Rezoning Transportation Analysis

Petition Number: 2020-124

General Location Identifier: Tax ID (07901504, 07901505)

Date	Description
09-14-20	First Review

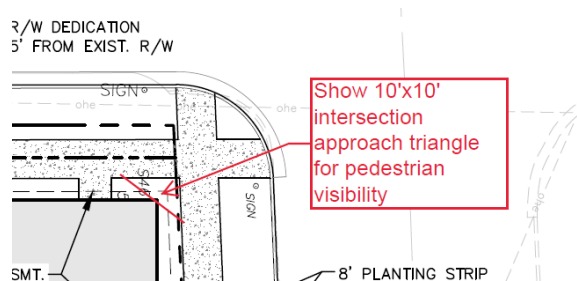
- Traffic Study** A Traffic Impact Study is not necessary for the complete review of this petition. If during the permitting process the site generates more than 2,500 daily trips, then a traffic study will be required.
- Revise the site plan and conditional note(s) to commit to install two CLDSM and PROWAG standard accessible ramps at the Dunloe Street and Sylvania Avenue intersection location, shown below.

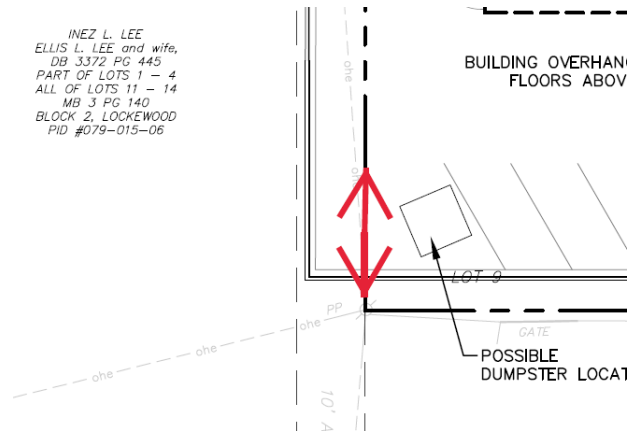
- Revise the site plan and conditional note(s) to confirm the proposed building footprint does not encroach within the pedestrian-approach intersection sight triangle, in conformance with CDOT's Sight Distance Policy. This triangle is measured from the back of the proposed sidewalk utility easement.

- Revise the site plan and conditional note(s) to provide a stub for future cross access within the existing alleyway.

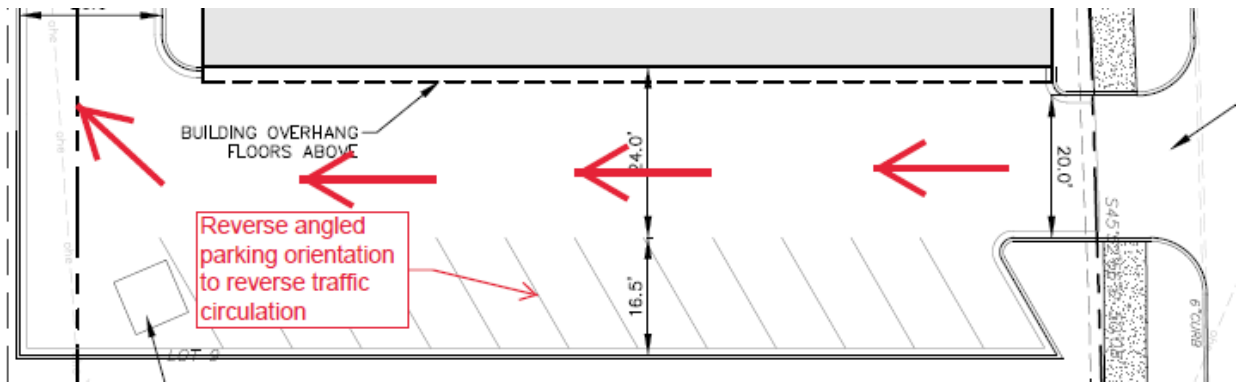
6. Revise the site plan and conditional note(s) to reverse the proposed one-way traffic circulation, so the ingress movement occurs from Sylvania Avenue (the higher volume street), and the egress movement occurs onto Dunloe Street. This orientation is preferred as turning movement decisions are made from the higher volume road.
